**REVISED PETITION TO AMEND
THE COMMISSION'S CERTIFICATION OF THE
ABENGOA MOJAVE SOLAR PROJECT**

09-AFC-5C

October 29, 2013

Abengoa Mojave Solar Project
Mojave Solar, LLC
13911 Park Avenue, Suite 206
Victorville, CA 92392

Figure 1

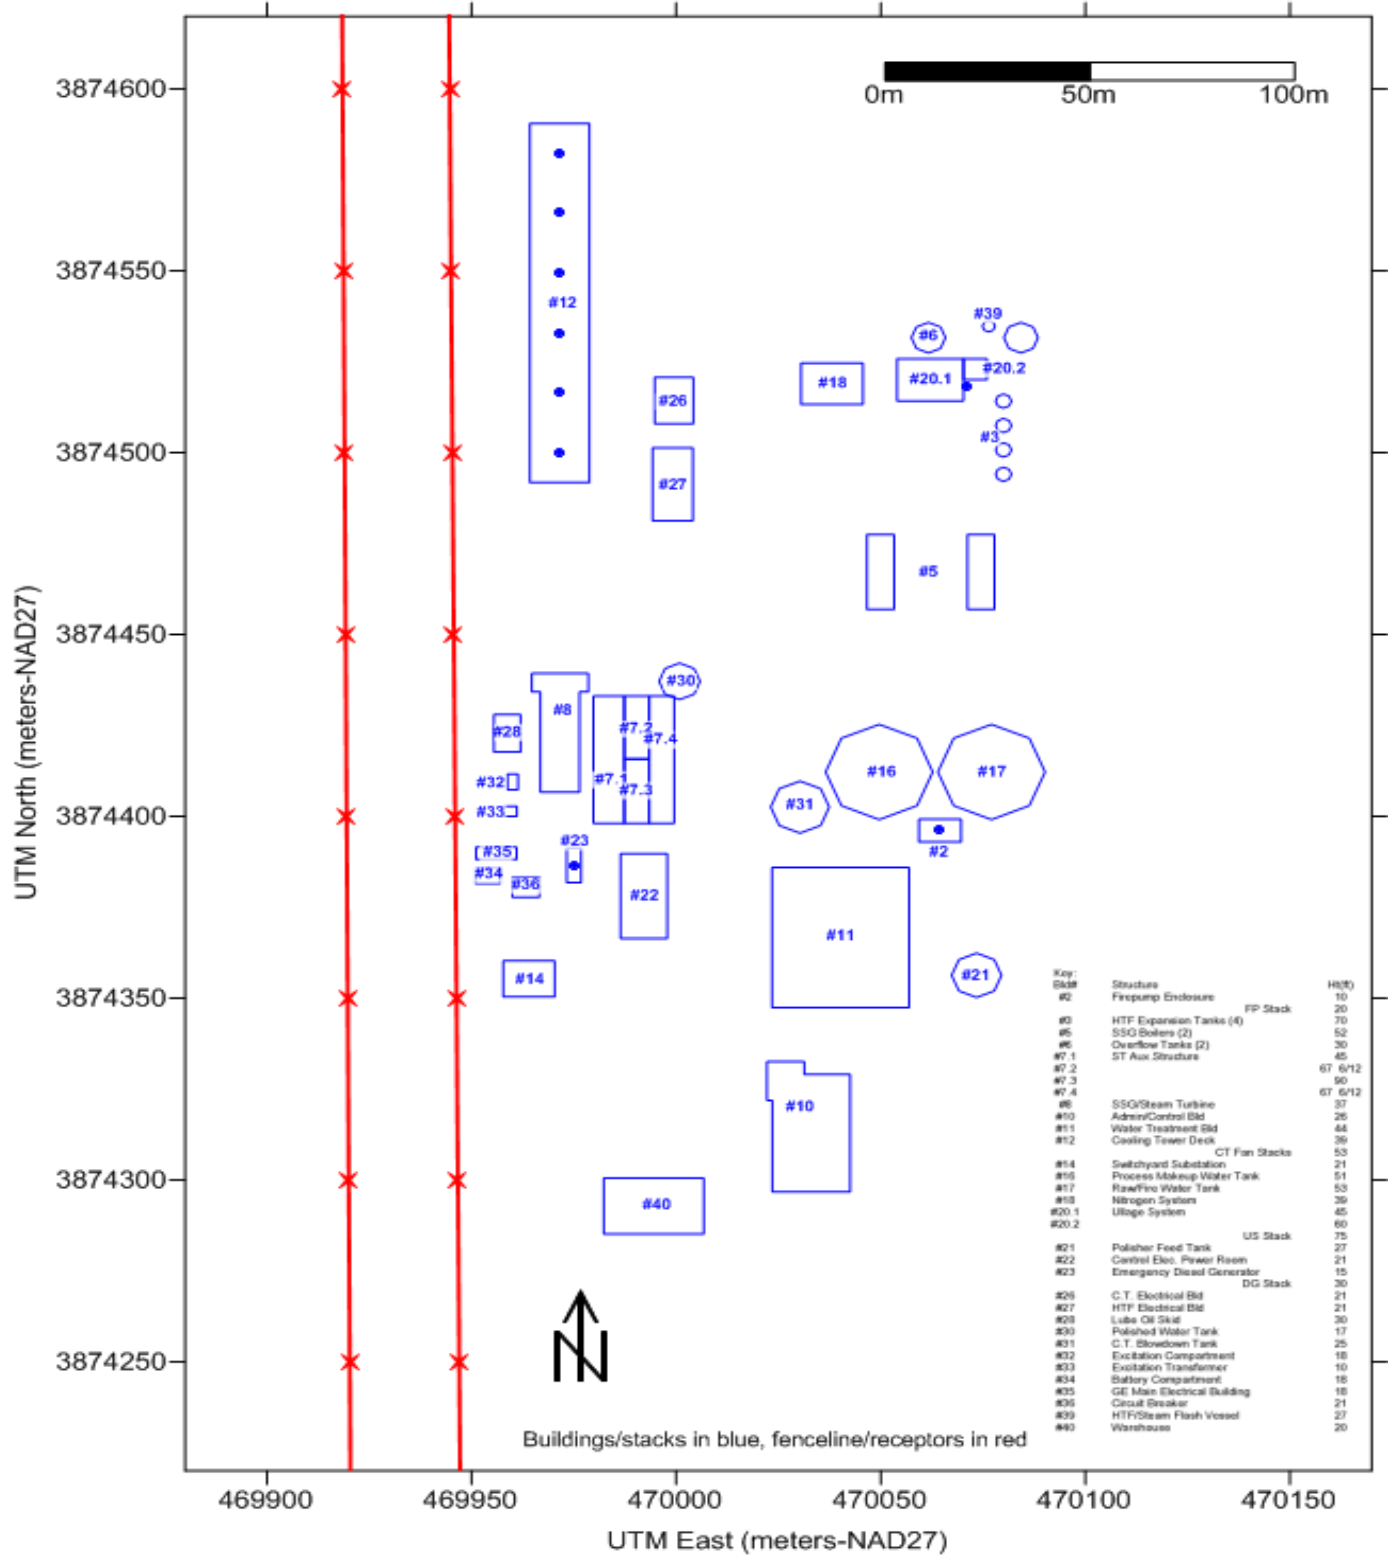
First, the changes to the facility general arrangement required a re-analysis of building dimensions using the most recent version of BPIP-PRIME (Version 04274). BPIP-PRIME generates the wind-direction specific building dimension data for input into AERMOD. BPIP-PRIME's use is required as all of the stack heights for the proposed amendment will not be Good Engineering Practice (GEP) height (the greater of 65 meters or the formula stack height). Figure 1 presents the revised building and stack locations for the Alpha and Beta Power Blocks. It should be noted that the equipment and building dimension layouts are identical for each power block.

HTF Ullage System Process Flow Block Diagram
and
HTF System Component Count and Fugitive Emissions Estimate

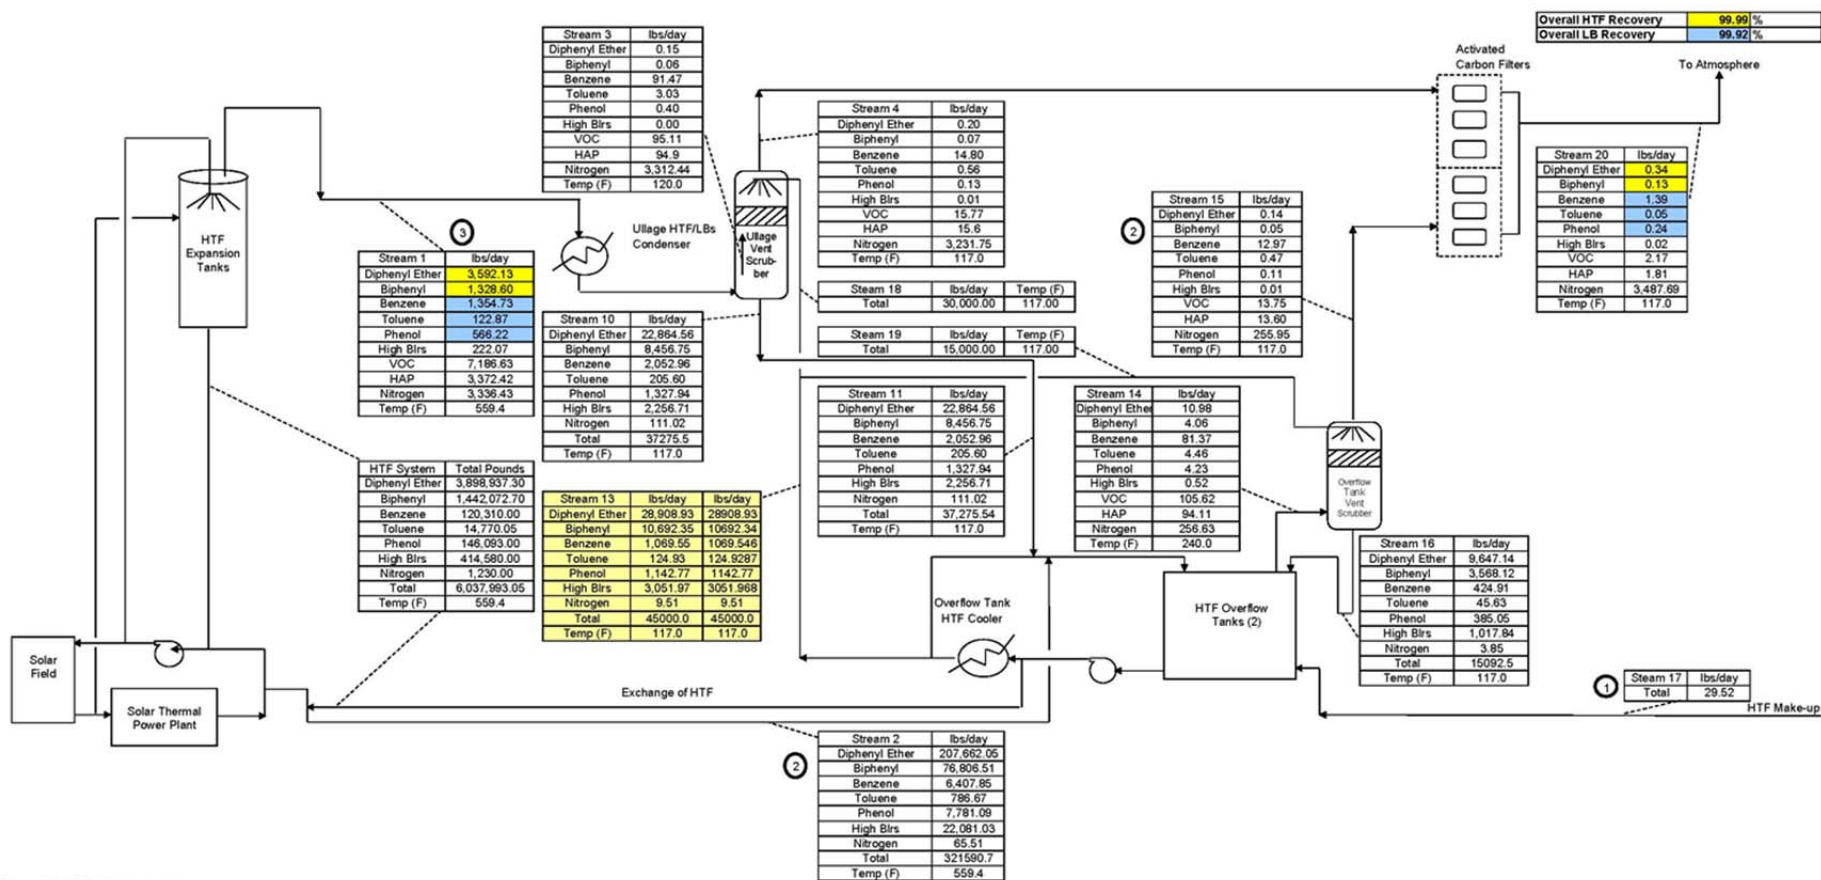
- *Remove the existing low boilers and high boilers cleaning distillation VOC control system and utilize a scrubbing and carbon adsorption VOC control system.⁸*
- *Update the two (2) vertical HTF storage tanks' condensers on the vent stacks with a scrubber on the vent stream for each plant.*

The Final Decision authorizes use of an HTF Expansion Vessel/Ullage Vent System consisting primarily of nitrogen-blanketed expansion and storage tanks, a Low Boiler and High Boiler cleaning system (distillation), with the use of cooling condensers on the tank vent stacks. This system has an overall VOC control/recovery efficiency of 99%. As proposed in this Petition, the primary change to the Ullage System will be the removal of the distillation system for the control of VOC emissions, and replacing it with a scrubber and carbon bed adsorption system. With the use of scrubbing and carbon adsorption, the vent coolers from the HTF Overflow Tanks are no longer necessary. The proposed modifications to the ullage system are summarized in the following table:

Attachment 2 contains the revised HTF Ullage System process flow block diagram.

- *Use of four (4) vertical ASME-rated expansion vessels (based on a reduction of HTF quantity) per plant, instead of five.*
